TO: Price River Coal Pile Project: Phase 2
AMR/043/904/L

RE: Meeting with Coal Regulatory Program

Recommended road reclamation (cross-section):

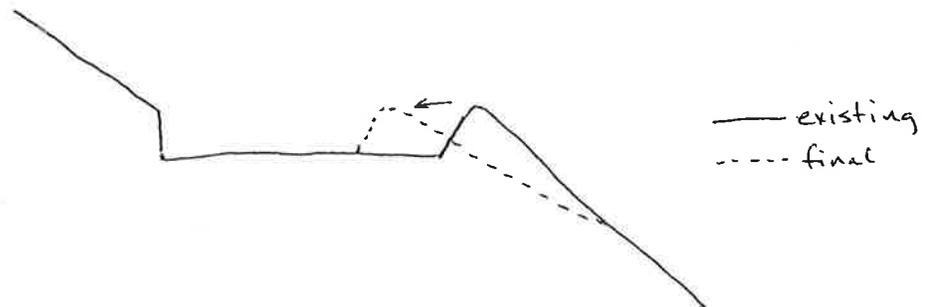
I explained that the AMR Program work at the site would probably continue through next fall, as the road would be used for Price River Coal Pile Project Phase 3 and Willow Creek Phase 2 work. Reclamation of the road is not in the scope of the current contract with Ned Mitchell Inc. Harold and Randy said that when all work is completed the road improvement (widening) should be reclaimed by cutting back the outslope and moving the berm over towards the west as shown below, thus narrowing the road and reducing the steepness of the outslope. The disturbed outslope should be reseeded. Where culverts have been installed in swale ditches, the culverts should be removed and the swales reconstructed.
